## **Evaluation of Street Modification and Parking Alternatives under Woodall Rodgers Freeway**

Project: DART General Planning Consultant VI (GPC6)  
TO39 D2 Subway – Traffic Evaluation

Subject: DART TO39 D2 Subway Project Development  
Evaluation of Street Modification and Parking Alternatives under Woodall Rodgers Freeway and Serving Perot Museum

# Option 1B

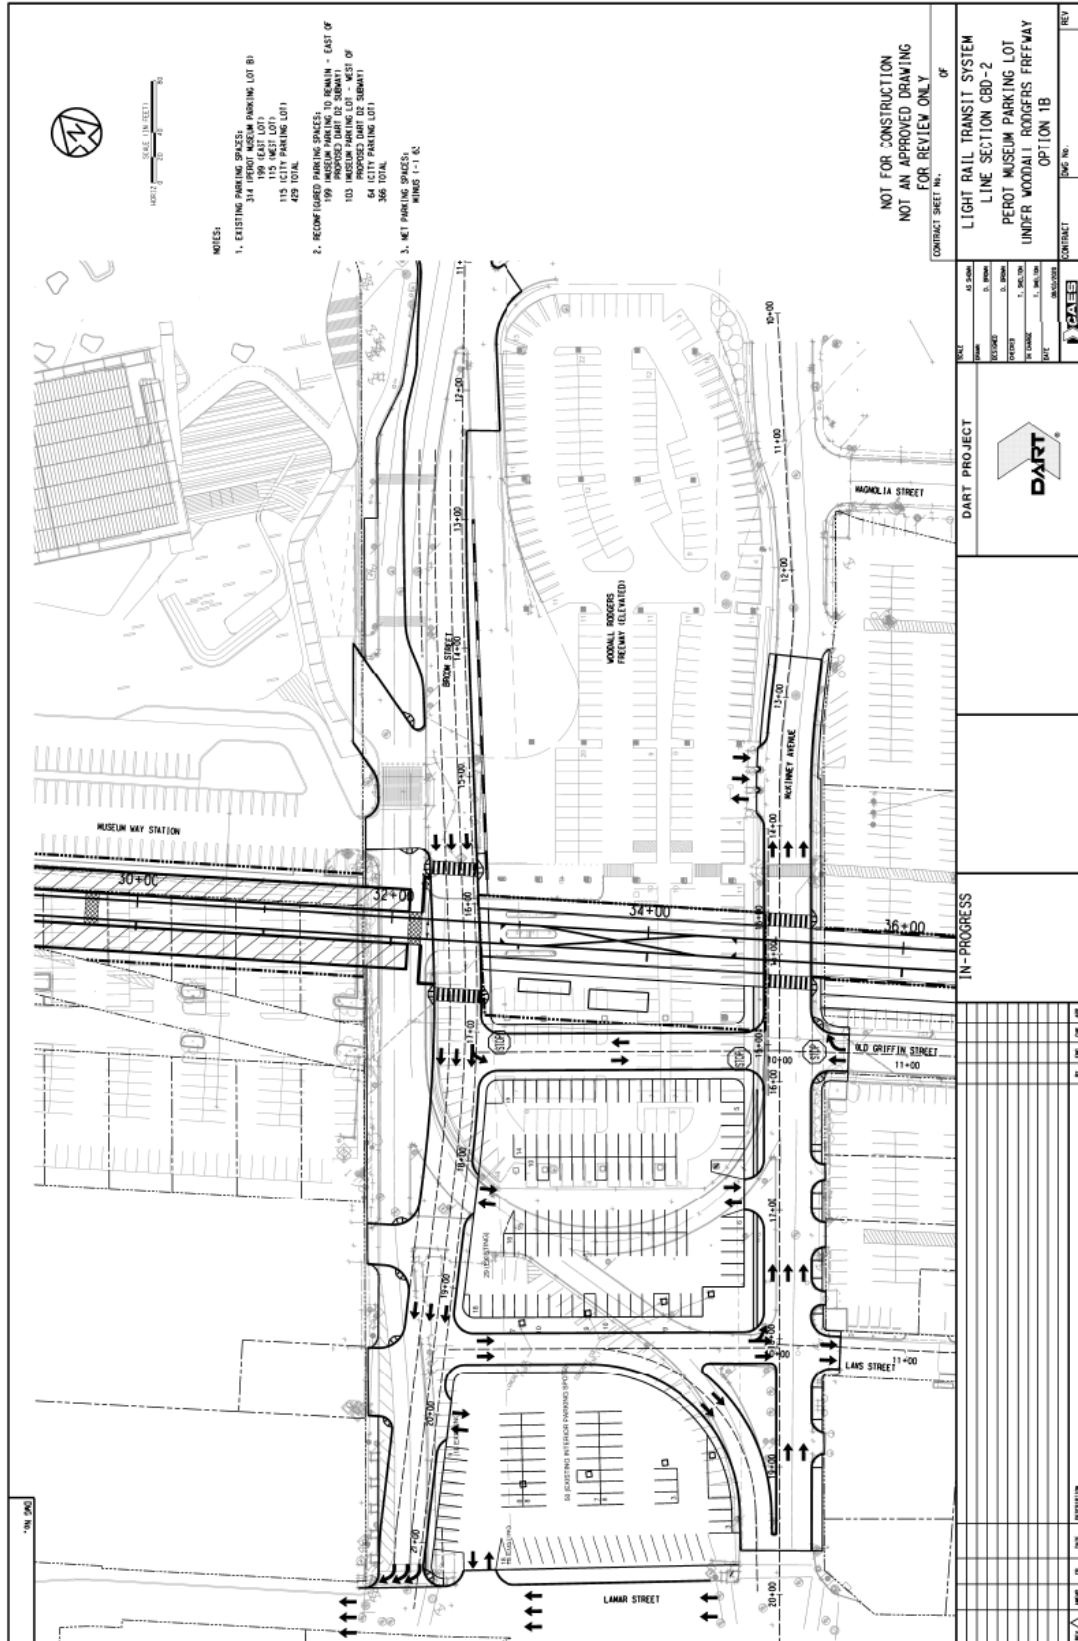
- Consensus around removing existing WB Broom to EB McKinney U-turn at Laws St under Woodall Rodgers Freeway
- Pending additional studies as to the traffic impacts, demand, and available right-of-way next to the Hooters property, a modified version of Option 1B is the preference, whereby the free-flow movement from Laws to Lamar is removed and Broom Street is punched through to Continental to allow for that left-turn southbound movement on Lamar.
- Where the extended Broom Street meets Continental, there may need to be a bump-out so the cars on Broom only must cross one of the dedicated left-turn lanes to head southbound on Lamar.
- Per the City's Traffic Signals Senior Program Manager, traffic signals will likely not work. It will likely need to be stop sign controlled.
- If a Broom connection to Lamar/Continental is not feasible, Option 1B as presented is the second preference.

- Option 1B with the City's proposed changes appears to be most optimal for traffic movement and additional connections via an extended Laws under Woodall Rodgers Freeway and the proposed connection of Broom Street to Continental.

Based on the assessment and feedback, DART is advancing a refined version of Option 1B (see Appendix C) in the FEIS and 30% design plans. Refinements made to original Option 1B include:

- Addition of an access point under the TxDOT ramp from Broom Street just east of the D2 tracks into the eastern parking lot under the freeway. This will eliminate the need for museum patrons to turn left onto Griffin and McKinney (crossing the tracks twice) to access the parking lot off McKinney. Signage and technology can be incorporated to provide parking information and space availability.
- Addition of two driveways into Parking Lot C north of Broom Street for buses and a proposed parking garage. These driveways will continue to be refined as necessary based on Perot Museum expansion plans.

Option 2B

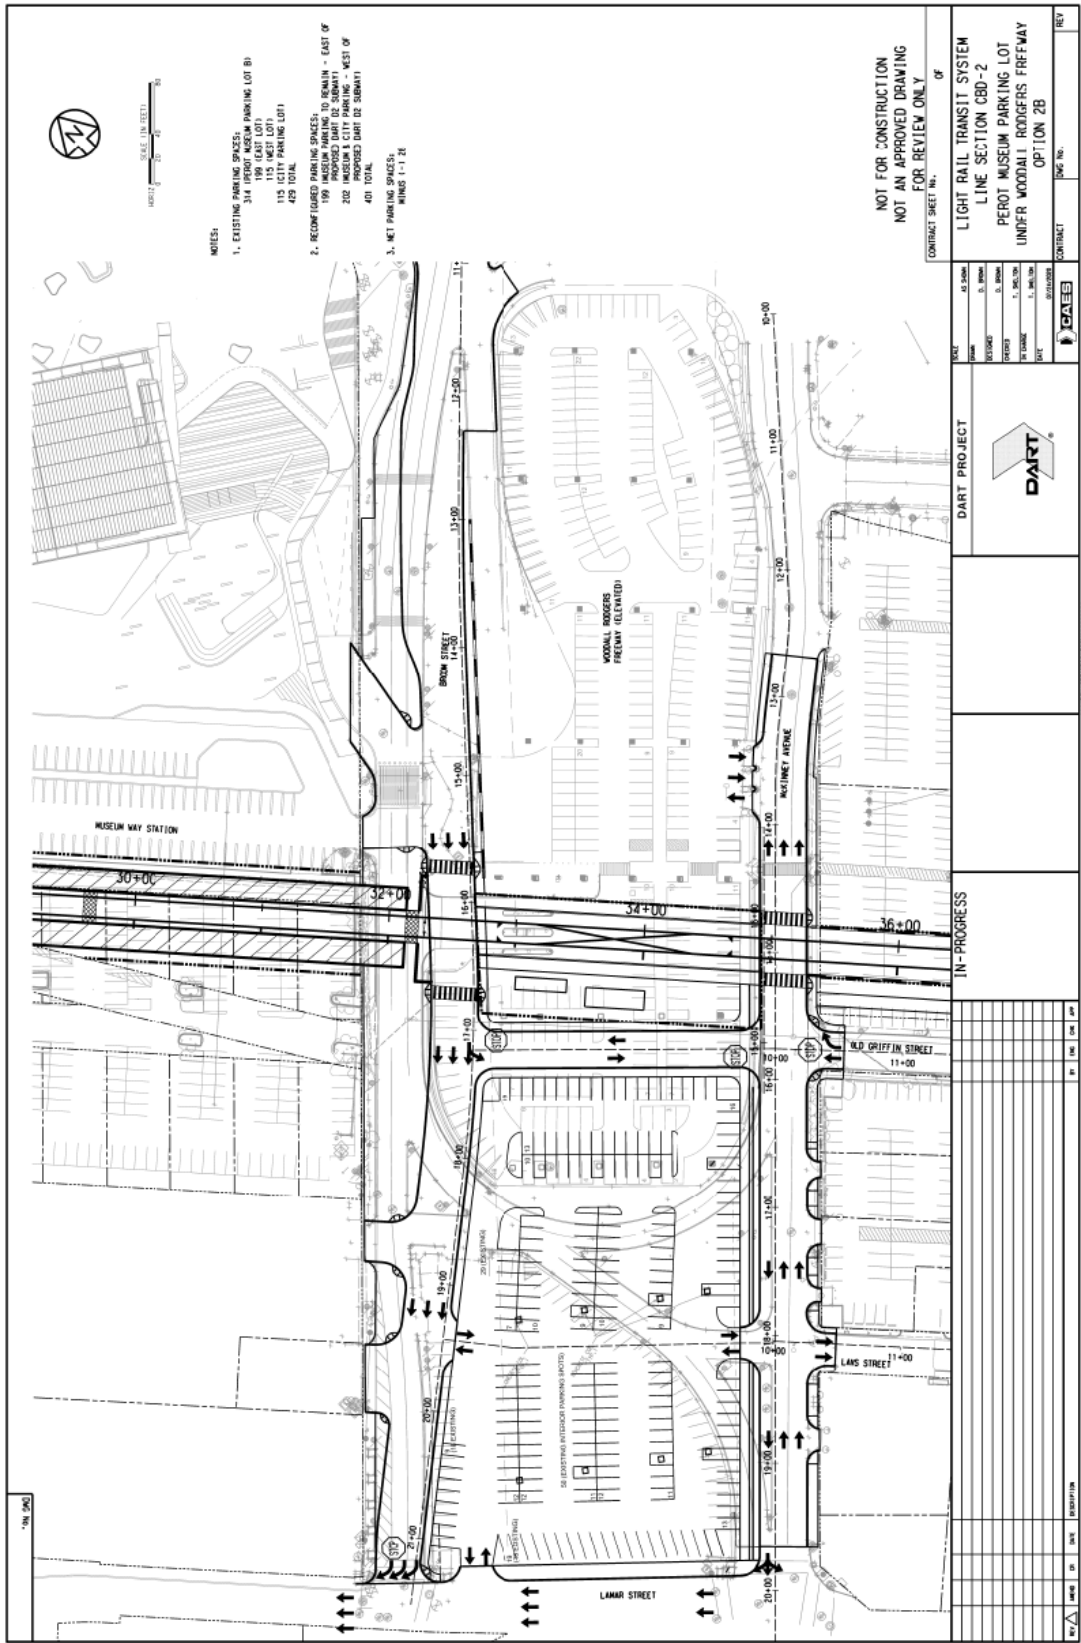
- They generally prefer Options 2B or 3 for roadway/parking lot reconfigurations which allows for two large parking lots under Woodall Rodgers Freeway. These options also reduce decision points and conflicts for traffic/pedestrians compared to 1A/1B.
